IDAP REPORT

Property:	17 Mackenzie Street HOMEBUSH Lot: 25 DP: 6479 DA2021.128
Proposal:	Construction of a front fence with gate.
Applicant:	M Turkmener
Owner:	M Turkmener
Date of lodgement:	31 May 2021
Notification period:	Not Notified
Submissions received:	N/A
Assessment officer:	E Black
Estimated cost of works:	\$10,000.00
Zoning:	R2-Low Density Residential - SLEP 2012
Heritage:	No
Flood affected:	Yes
Is a Clause 4.6 Variation Proposed:	No No
RECOMMENDATION OF OFFICER:	APPROVAL

Image 3: The amended plan with the gaps at the base of the fence.

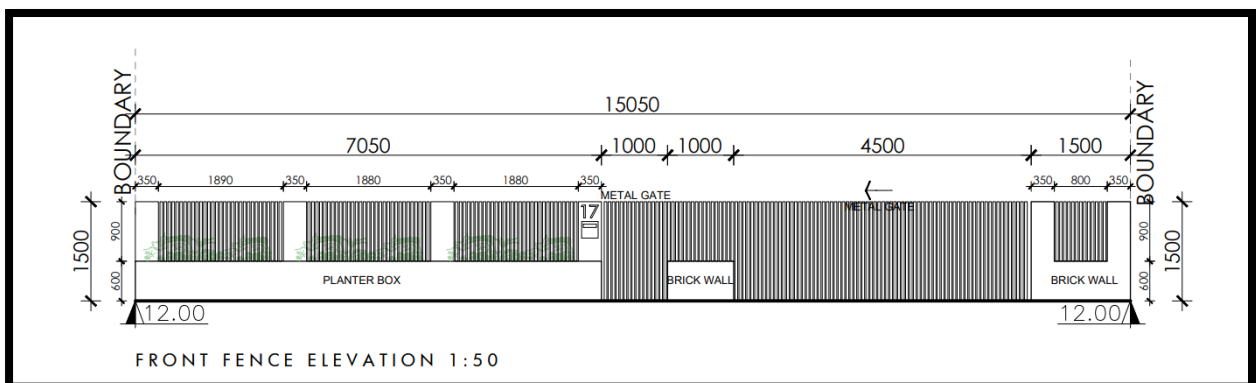
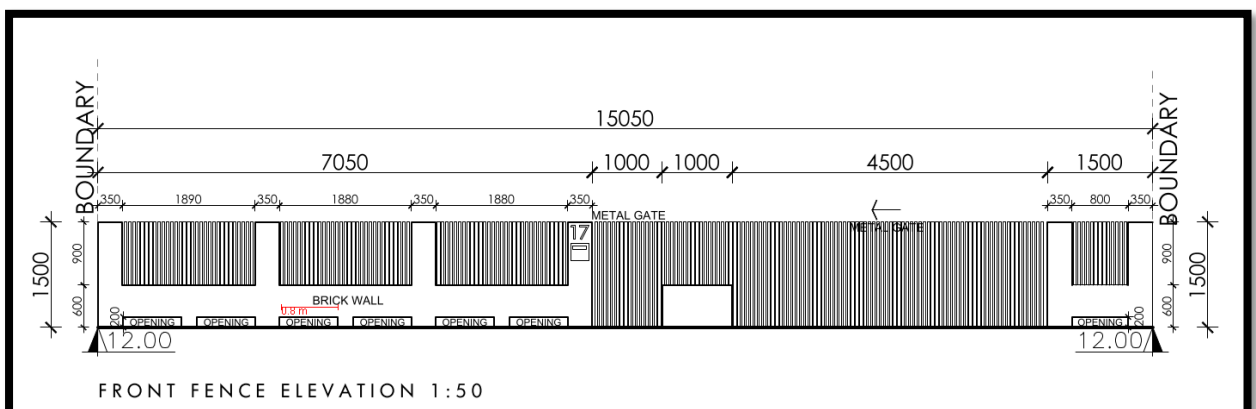
The applicant is permitted, under complying development, to have a fence **upto** 1200mm on this site as long as the fence does not restrict the flow of any floodwater (Part 3 Housing Code, Section 3.29 Development standards for fences). The proposed fence height of 1500mm which triggers the need for development consent. Therefore, it is the additional 300mm in height which approval is sought.

The application was referred to Council's Development Engineer as the site was flood effected. Council's Development Engineer commented that the submitted fence design was not suitable for the site and the fence needed to be redesigned to allow water to flow unimpeded over the site. The applicant amended their application to include suitable sized gaps at the base of the fence. This amendment is supported by the Development Engineer.

Council has received an application for the construction of a front fence with a pedestrian and a driveway gate. More specifically, the proposal is for a 1500mm high fence (painted in *Whisper White Dulux* or similar) with a 600mm solid brick base topped with 900mm powder coated aluminium angled upright slats spaced a minimum of 20mm apart. The fence has been designed with seven (7) ground level gaps (200mm (H) x 800mm (W)), to allow for overland flow of stormwater through the structure.

- A. The front fence access gates must not open onto Council's public footway. The access gate is to open inwards onto private property.
- B. The open gaps at the base of the fence must be at least 200mm in height and allow water to flow through the fence and gates unimpeded.
- C. A grate that does not impede water flow through the structure, as an optional fence decorative element is permitted. This grate cannot reduce the minimum

size of the opening of 200mm in height.

Image 11: Showing extent of flooding in area(subject site outlined in red)

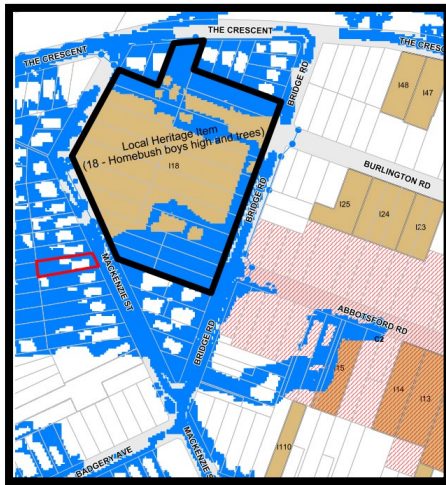
The subject site has been identified as being at or below the flood planning level. The application has been reviewed by Council's Engineer who has advised that subject to suitable conditions, the development is considered compatible with the flood hazard of the land. In addition, it will not result in significant adverse effects on flood behaviour or the environment and is not likely to result in unsustainable social and economic loss. The proposed development is considered to satisfy the objectives of this clause.
